**Request for Additional Information No. 547, Supplement 3**

**U. S. EPR Standard Design Certification**

**SRP Section: 03.07.02 - Seismic System Analysis**

**Question 03.07.02-76:****Open Item****Follow-up RAI 371, Question 03-07-02-67 (Supplement 24 Response)**

**Figure 3.7.2-16—Static FEM vs. Dynamic FEM Spectrum Comparison at Elev. +200ft, 5 in (+61.09m)  
(Dome Apex) of Reactor Shield Building, 5% Damping, Z-Direction**

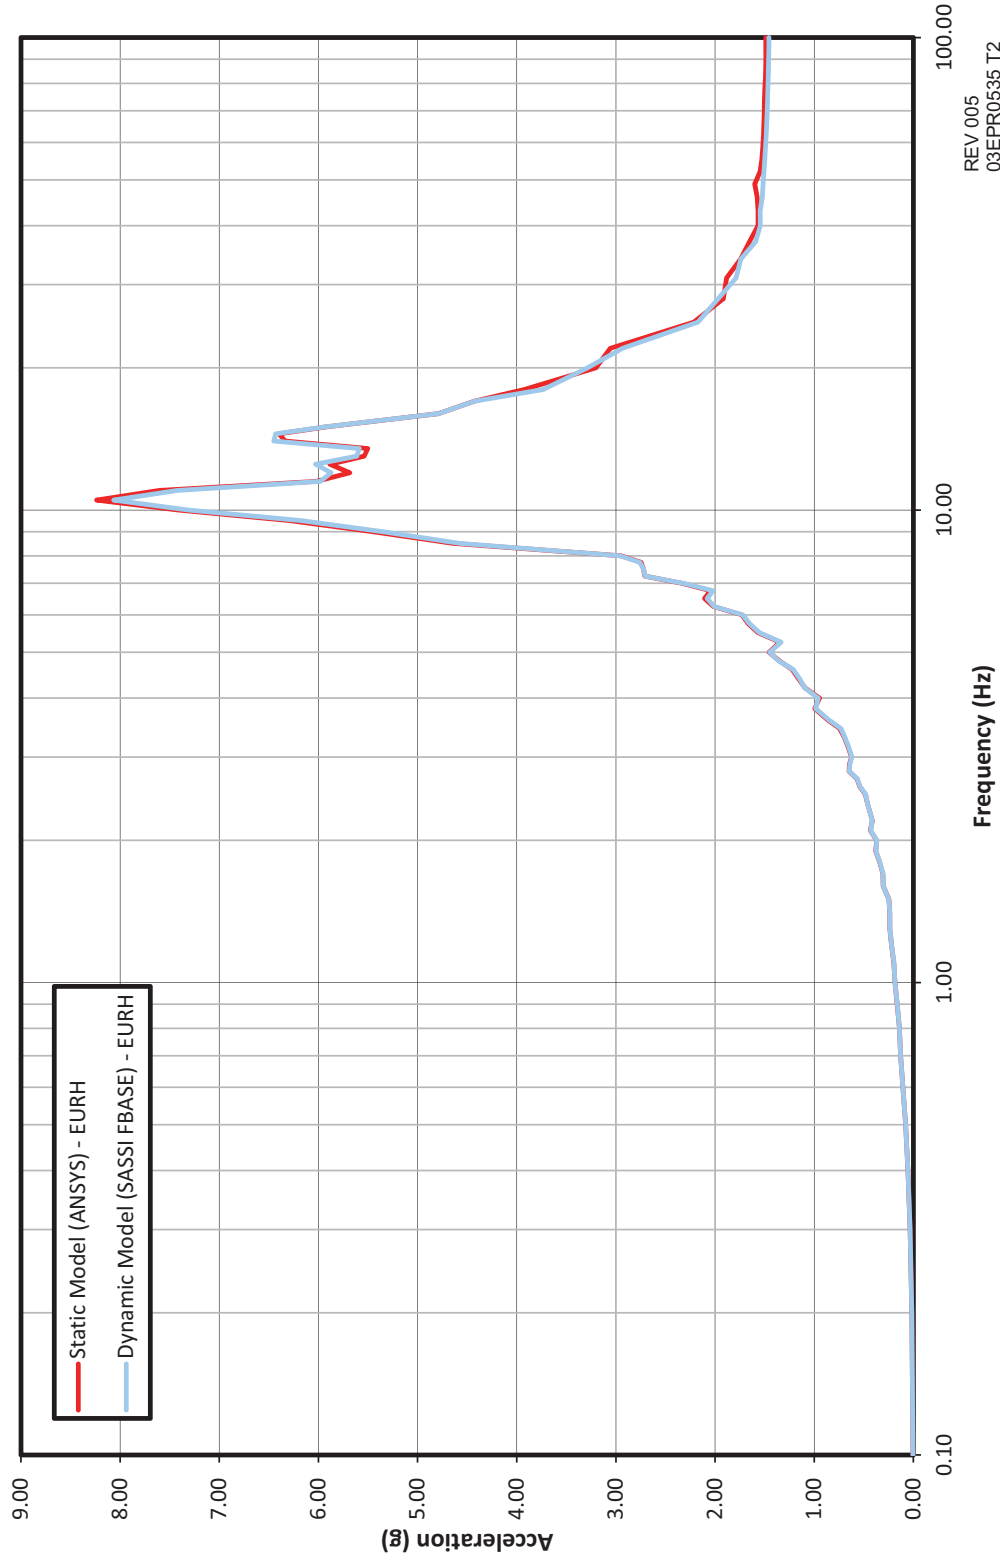
1. The applicant has noted that there is a discrepancy in the dome ISRS of the Shield Building. At a frequency of approximately 15 Hz the static model results exceed the dynamic model results by about 23 percent. Although the applicant claims this is due to a small deviation in the ANSYS model from the perfect dome geometry around the apex of the dome and due to irregularities in the dome surface geometry, it is not clear why this would lead to a difference of over 20 percent in the results for the two models. In addition the ZPA for the static model exceeds that of the dynamic model by about 14 percent.

1. The dome of the Reactor Shield Building for the dynamic (MTR/SASSI) model is based on the latest design drawing. However, the static (ANSYS) model was developed prior to issuance of the design drawing and was therefore modeled with an approximate curvature (radius). Consequently, the in-structure response spectra (ISRS) for the dynamic and static model differed as shown in RAI 371 Question 03-07-02-67 (Supplement 24 Response). The static model dome has been modified to the same geometry shown on the design drawing, making the geometry consistent with that of the dynamic model. The resulting In-Structure Response Spectra (ISRS) match very closely as shown in updated FSAR figures 3.7.2-14 through 3.7.2-16 in the attached mark-up, demonstrating that the accurate modeling of the

dome curvature resolves the differences previously shown in RAI 371. The ZPAs are also now in agreement.

**Figure 3.7.2-20—Static FEM vs. Dynamic FEM Spectrum Comparison at Elev. +26 ft, 3 in (+8.00m) - Safeguard Building 1, 5% Damping, X-Direction**

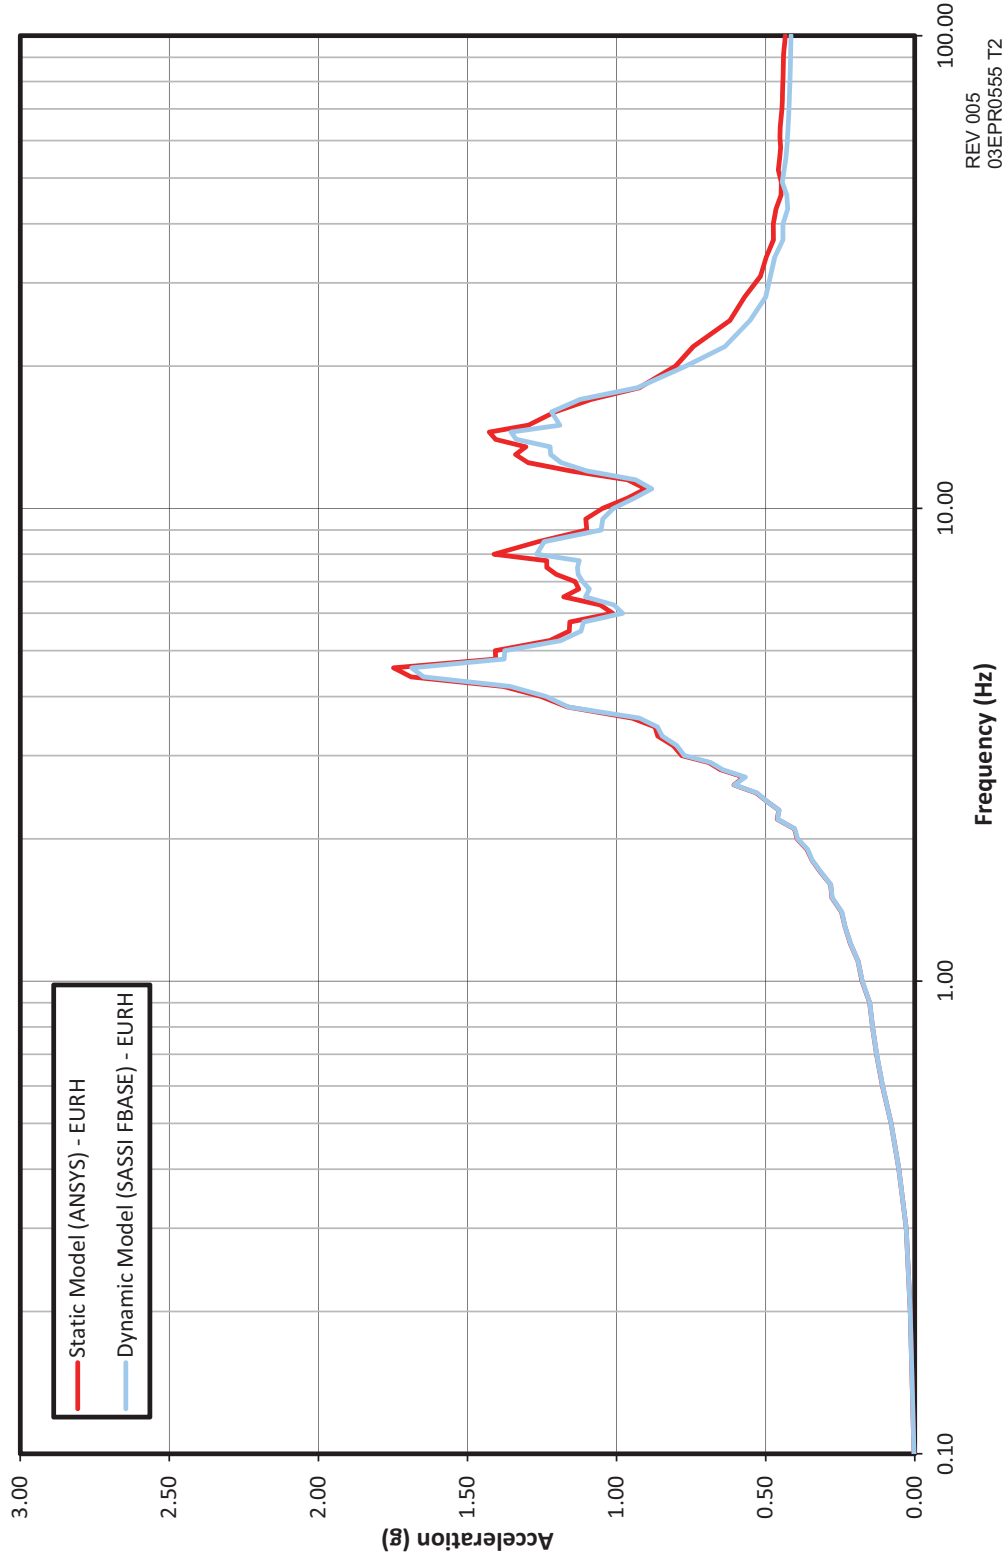
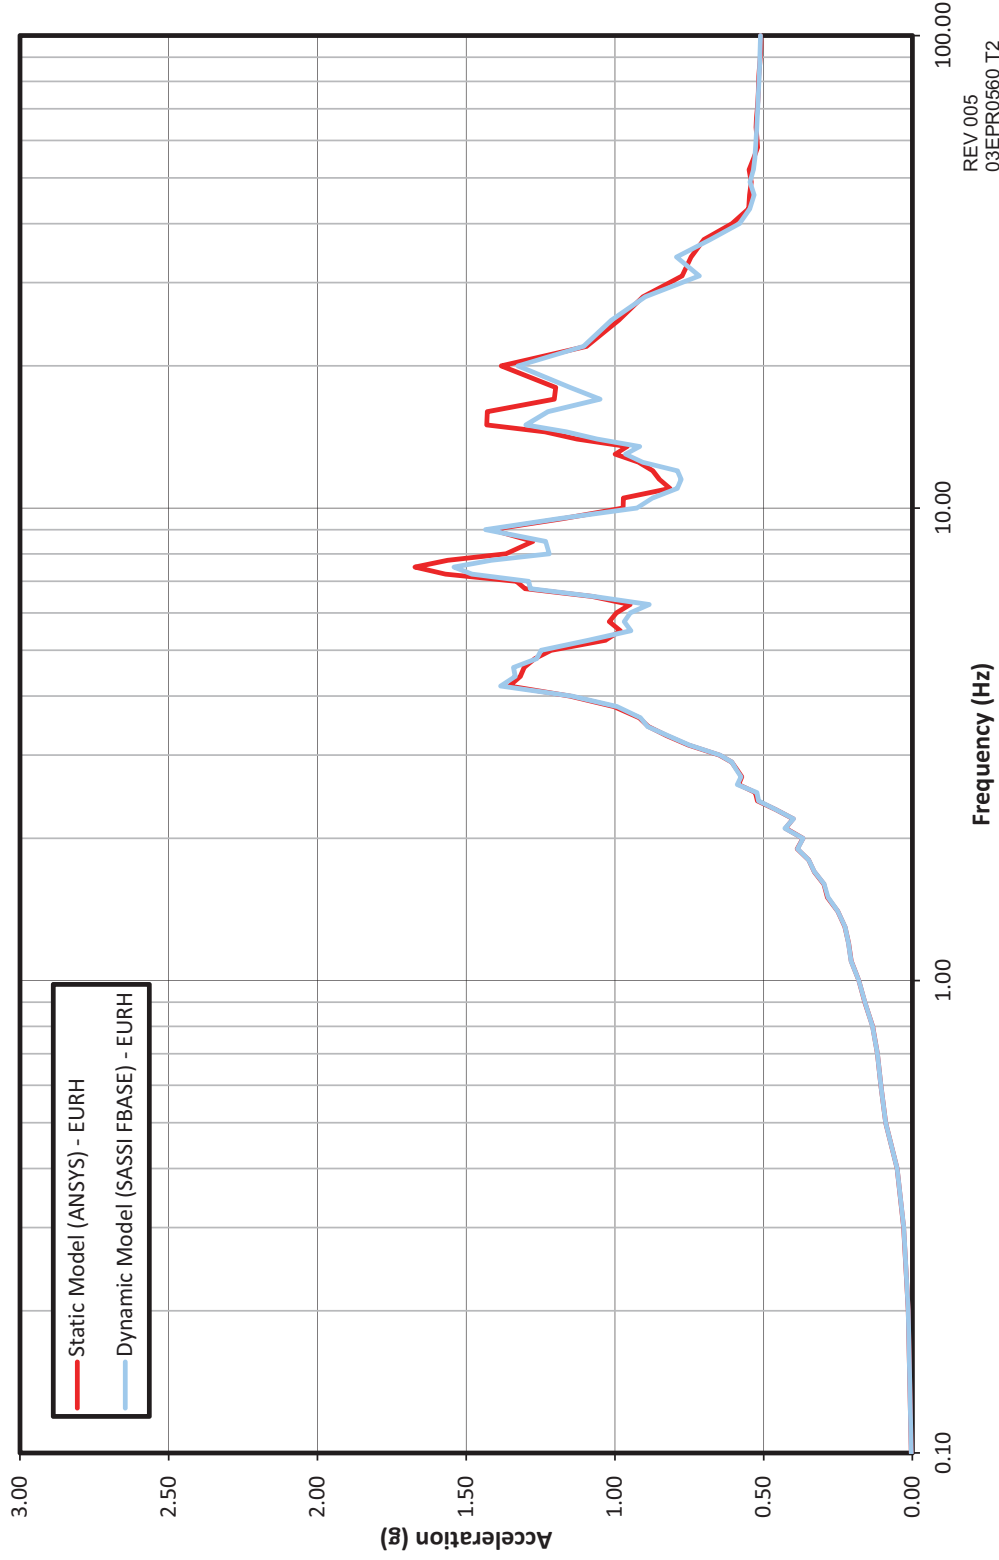
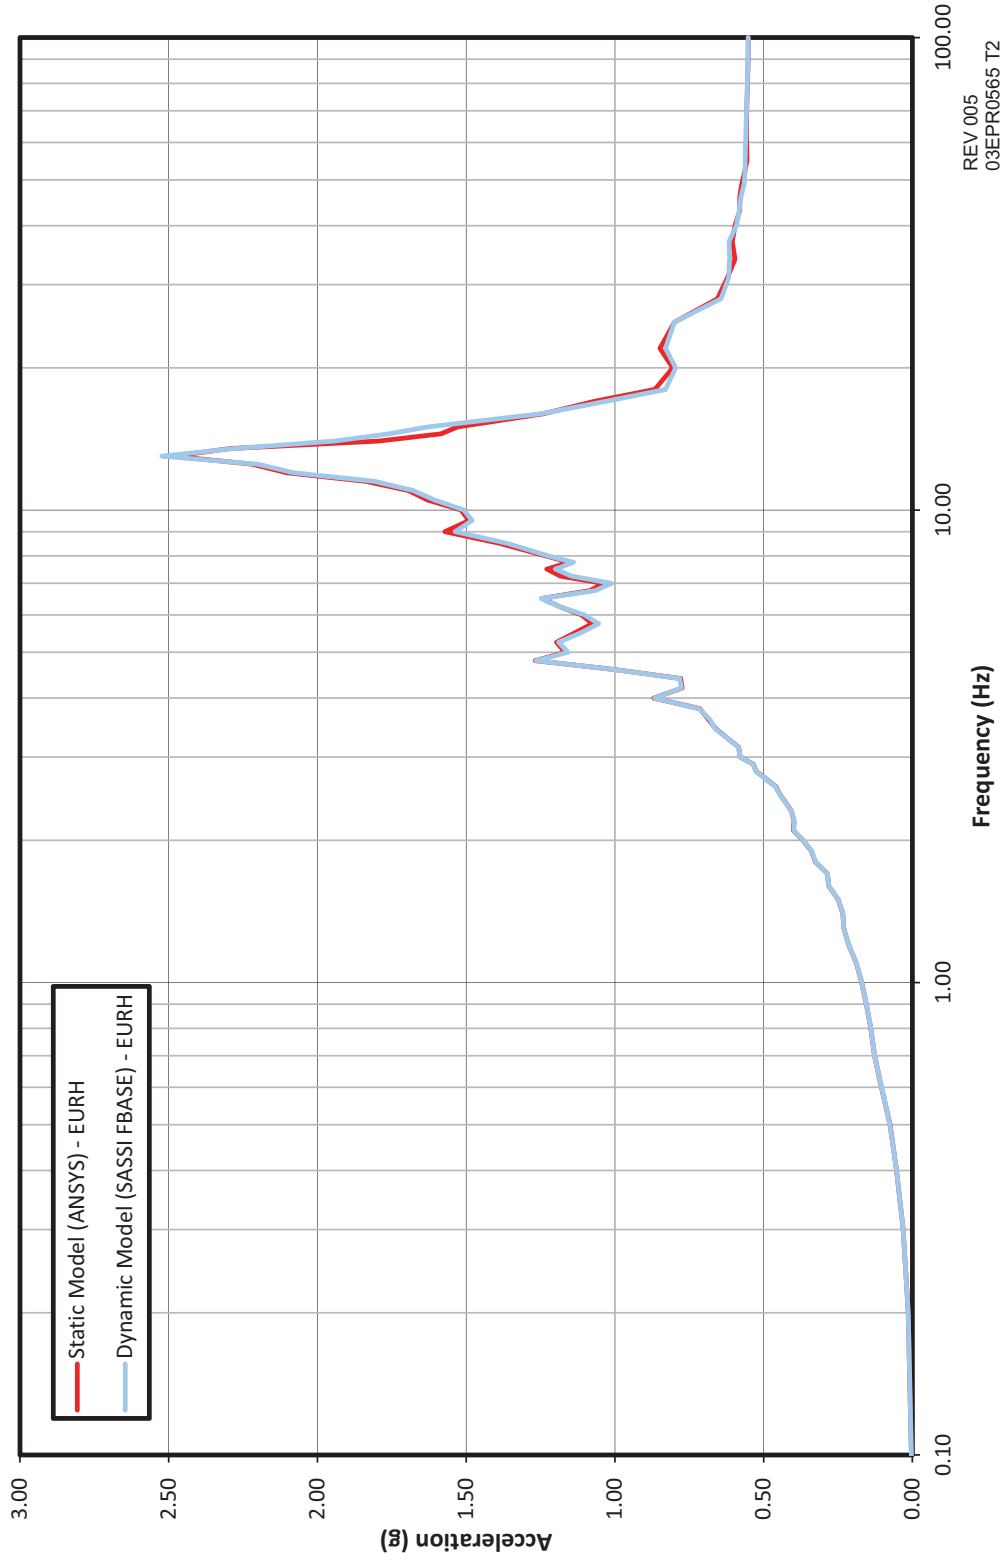
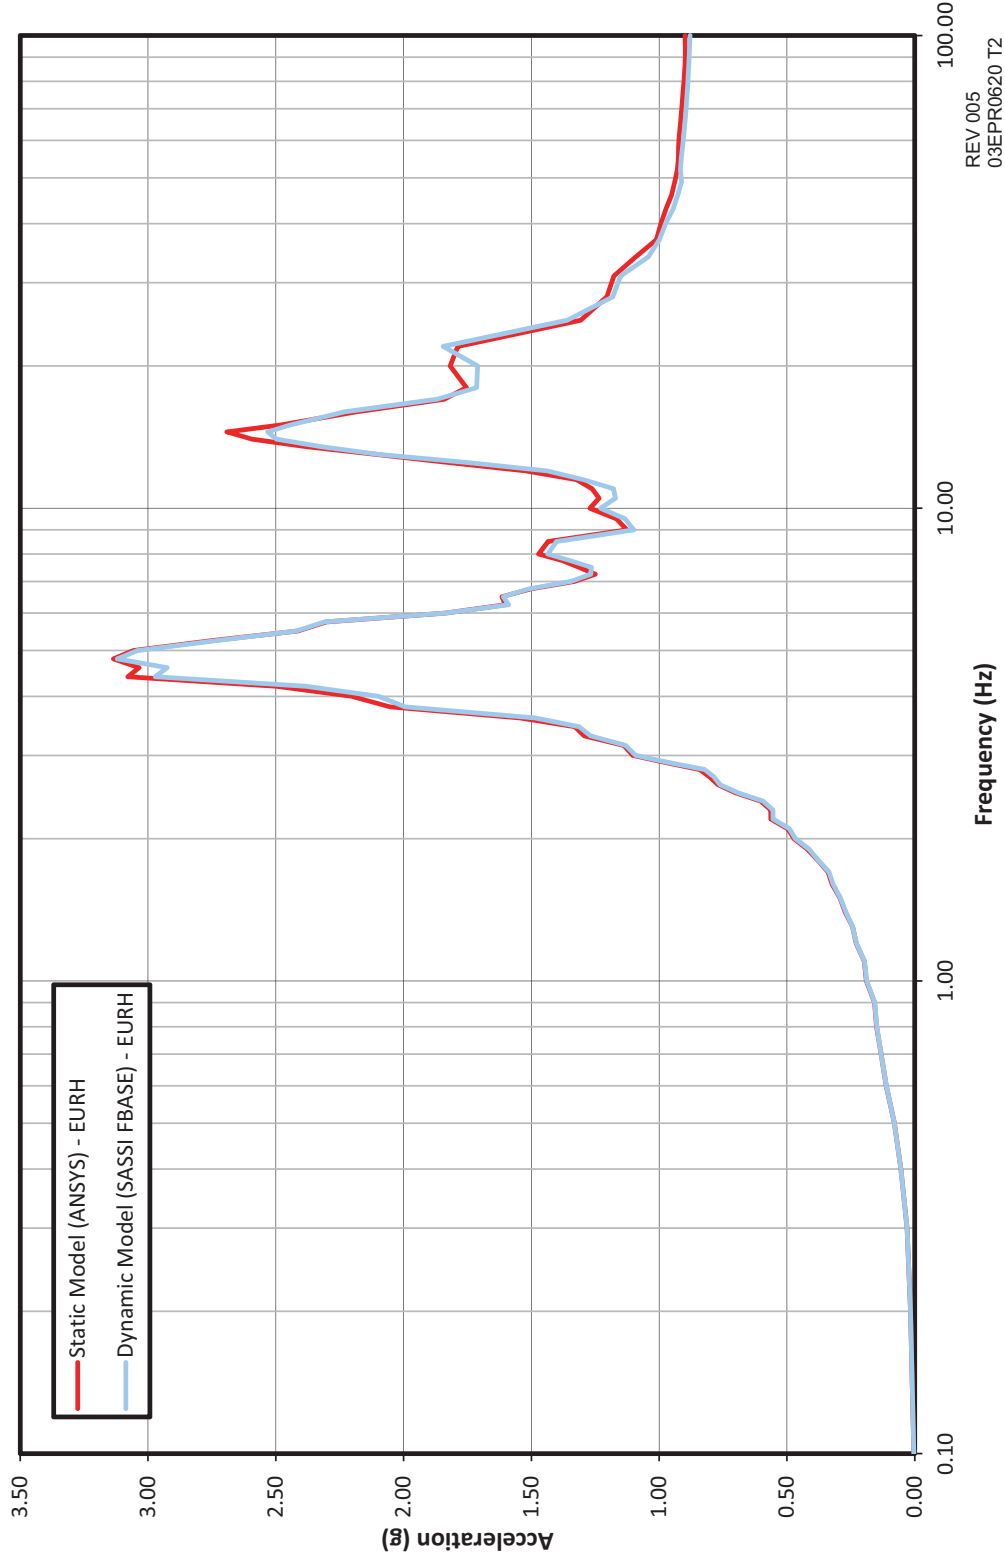
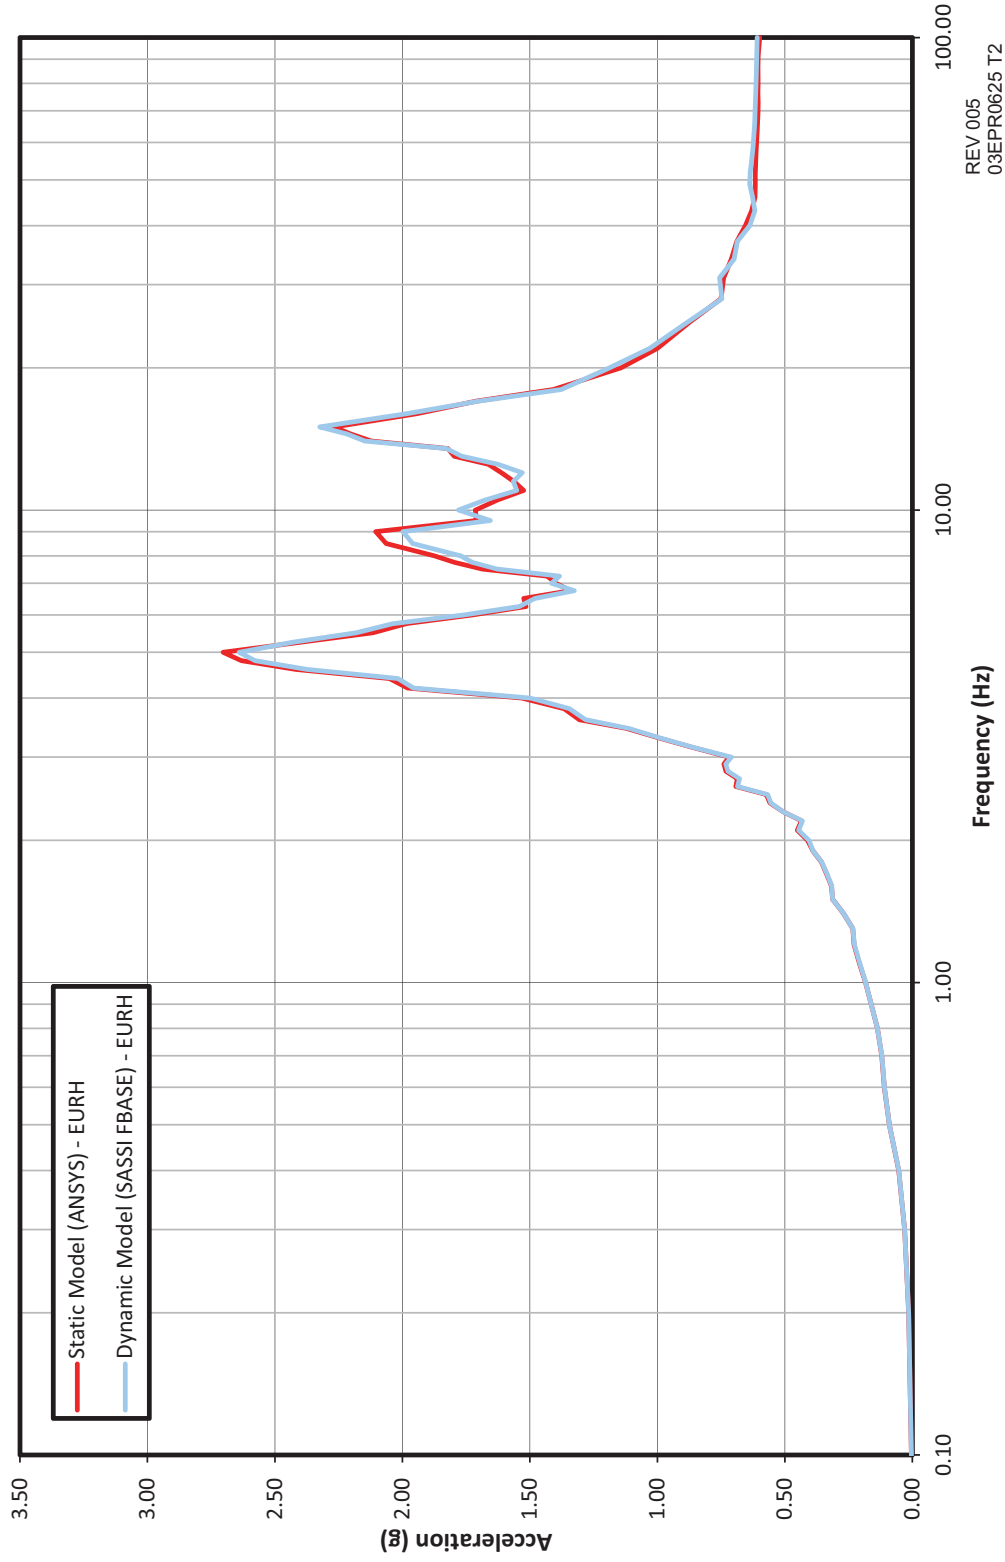
5. A comparison of Y-direction ISRS for Safeguard Building 1 (Figure 03.07.02-67-8) and X-direction ISRS for Safeguard Building 2/3 (Figure 03.07.02-67-19) at an elevation of 26 feet 3 inches shows that the static model results at frequencies less than 10 Hz to be 21 and 24 percent higher, respectively, than the dynamic model results. The envelope of the ISRS shown on FSAR Figures 3.7.2-81(Revision 3) for Safeguard Building 1 is about 5 percent

lower than the static result at a frequency of about 7.5 Hz. For Safeguard building 2/3 the envelope of ISRS shown on FSAR Figure 3.7.2-87 (Revision 3) exceeds both the static model and dynamic results. This might suggest that the comparison of static and dynamic results for the Safeguard Building at elevation 26 feet 3 inches are acceptable because the envelope of ISRS is approximately equal to or exceeds the static model result. However at frequencies below 10 Hz, the CSDRS for the EUR medium and soft soil cases exceed the CSDRS for the EUR hard soil case upon which the examples provided with the response are based. If the EUR medium or EUR soft time histories were used for the fixed base analyses it is likely the results at frequencies below 10 Hz would be higher than that provided with the response and might possibly exceed the envelope of the ISRS shown on FSAR Figures 3.7.2-81 and 87.

5. As described in Item (2), the BONI geometry from the static model has been incorporated into the dynamic model and new ISRS for Safeguard Building 1 (Figure 03.07.02-67-8) and X-direction ISRS for Safeguard Building 2/3 (Figure 03.07.02-67-19) at an elevation of 26 feet 3 inches have been generated. The ISRS comparisons are now more favorable. See updated FSAR figures 3.7.2-17 through 3.7.2-34 in the attached mark-up for Safeguard Building ISRS comparisons.
